BULLETIN: CA-SB-17-72-20

SERVICE BULLETIN

17M,P,S CONTACT SEAL GUIDE RING

FIGURE 1

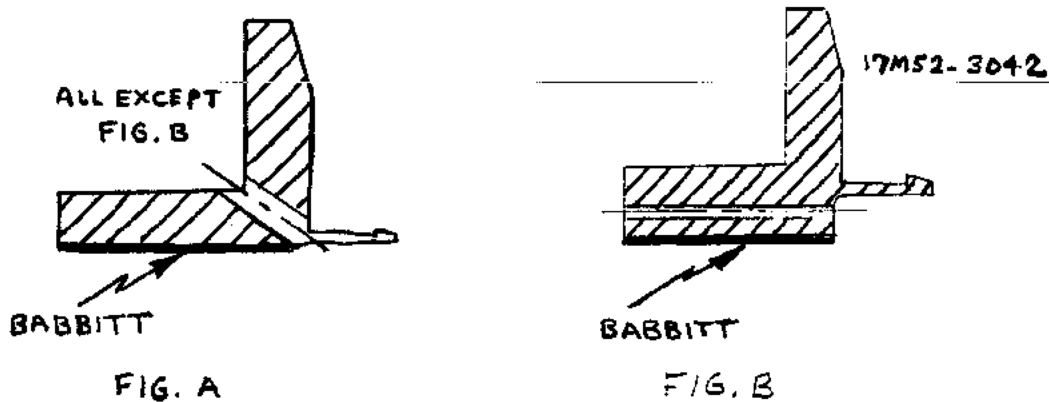
The chart on Figure 1 gives the nine possible guide rings with their respective hole sizes and number of holes. If a guide ring with a part number other than one of those listed is found, contact your Replacement Components Division Account Representative for assistance.

GUIDE RING	HOLE SIZE	NO. OF HOLES
17M32-2033	5/64"	3
17M42-2073	3/32"	3
17M42-2422-1	5/64"	3
17M52-2103	5/64"	3
17M52-3042	1/16"	2
17S32-1902	3/32"	3
17SA32-2013	5/64"	3
17M421-1103-1	7/64"	3
17M421-1373	7/64"	3
